Project	IEEE 802.16 Broadband Wireless Access Working Group < http://ieee802.org/16 >	
Title	Interference Knowledge Impact on Link-to-System Mapping	
Date Submitted	2007-09-19	
Source(s)	Robert Novak, Mo-Han Fong, Aaron Callard, Kelvin Au, Steve Yuan, Sophie Vrzic Nortel Networks 3500 Carling Avenue Ottawa, Ontario Canada K2H 8E9	Voice: +1-613-763-7863 E-mail: rnovak@nortel.com Voice: +1-613-765-8983 E-mail: mhfong@nortel.com * http://standards.ieee.org/faqs/affiliationFAQ.html >
Re:	IEEE 802.16m-07/031– Call for Comments on Draft 802.16m Evaluation Methodology Document	
Abstract	This contribution discusses the knowledge of interference impacts on the receiver, and proposes a method to model this in the PHY abstraction. In addition, baseline assumptions for the knowledge of interference statistics are also proposed.	
Purpose	To incorporate the proposed text changes into the Draft 802.16m Evaluation Methodology Document (IEEE C802.16m-07/080r3)

Interference Knowledge Impact on Link-to-System Mapping

Figure 1. PHY abstraction simulation procedure for average interference knowledge.

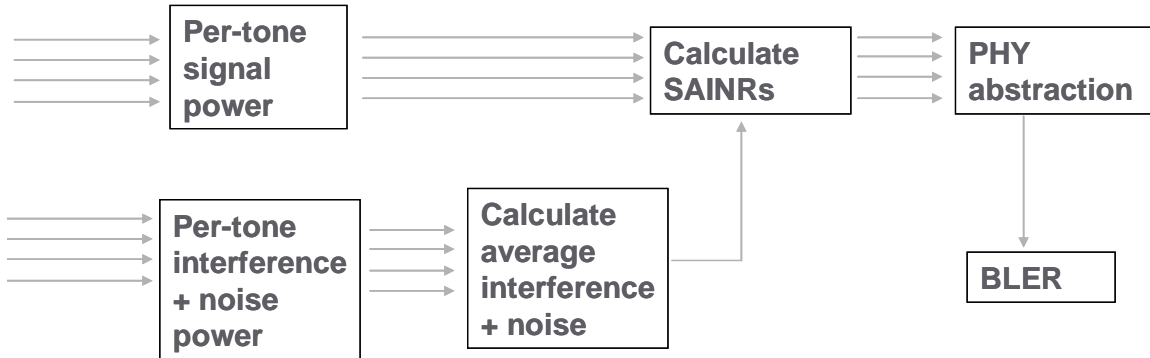
5. Add Figure 1 as Figure 11 in section 4.5.6.2. Add the following text after the figure.

“As seen from Figure 11, the interference plus noise in the post processing SINR equation are averaged over all the occupied sub-carriers. Thus, the per-tone signal-to-average interference plus noise (SAINR) is calculated and used as input to the PHY abstraction. This method of accounting for the effect of practical interference knowledge applies to all transmitter/receiver configurations.”
